**DEVIATION REQUEST
AND DECISION FORM IN
ASSOCIATION WITH A
REQUEST FOR A PUD
MODIFICATION FROM
THE ECM**

PROJECT INFORMATION	
Project Name :	Waterside
Schedule No.(s) :	71114-04-112
Legal Description :	All of the waterside condominiums subdivision, recorded in Plat Book 2, At Page 47 Records of El Paso County, Colorado

WATERSIDE TOWNHOMES
 DEVIATION REQUEST - ECM SEC. 2.2.4.B.7.
 FIGURE 2-17, TABLE 2-7
 PCD FILE NO. PUDSP-22-009

PROPOSED TYPICAL SECTION – PRIVATE ROADWAY TRACT

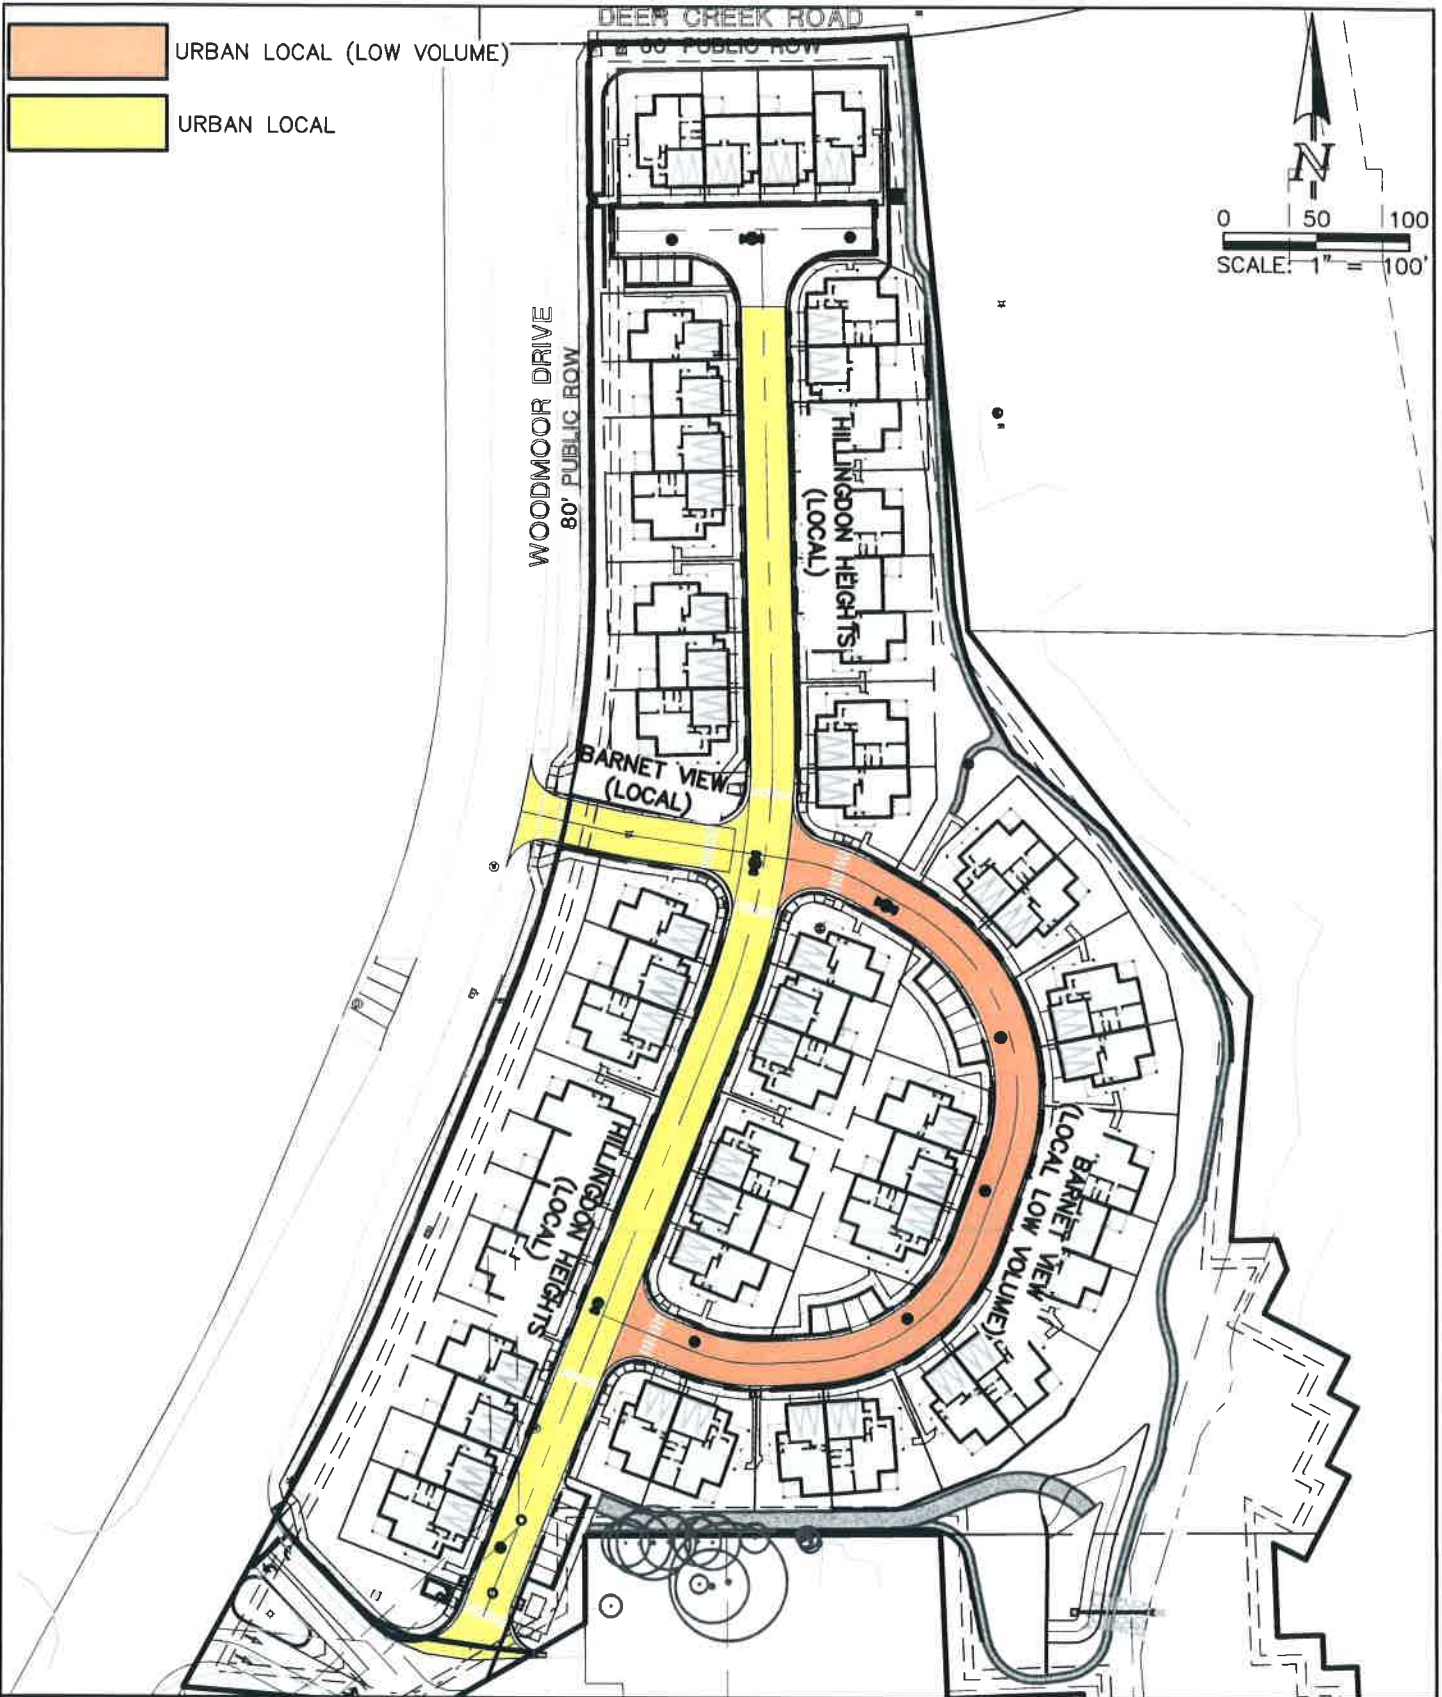
Typical urban local cross section (50' ROW with 30' asphalt mat) – ECM 2.2.4.B.7 (Fig. 2-17)
Table 2-7
Standard Detail SD_2-2

200' minimum tangent length between two Broken Back curves – ECM2.3.3.F.3

A standard county public urban local roadway is contained within a 50' wide public right of way (with a 30' wide asphalt mat). The proposed private street section is contained within a 29' wide private tract (owned and maintained by the Homeowners Association) and includes a 24' wide asphalt mat. All private roads to be built using county standard curb and gutter, signage and pavement thickness, as well as adhering to county maximum grade criteria. See attached proposed street section, and exhibit depicting locations of urban local and urban local (low volume) private roads. Broken Back curve tangent lengths of 30.07' and 36.58' are proposed on the small looped private Barnet View, where 200- minimum tangent length is required (same as an arterial roadway).

- HILLINGDON HEIGHTS – URBAN LOCAL ROADWAY (MIN. 200' CL RADIUS)
- BARNET VIEW BETWEEN WOODMOOR DRIVE AND HILLINGDON HEIGHTS – URBAN LOCAL ROADWAY (MIN. 200' CL RADIUS)
- BARNET VIEW EAST OF HILLINGDON HEIGHTS – URBAN LOCAL (LOW VOLUME) (MIN 100' CL RADIUS)
- 16 HOMES = 160 ADT < 300ADT
- NO TANGENT LENGTH MINIMM FOR LOCAL (LOW VOLUME) IDENTIFIED IN ECM

The Deviation is only valid until and unless the Board of County Commissioners approves the Planned Unit Development Modifications.
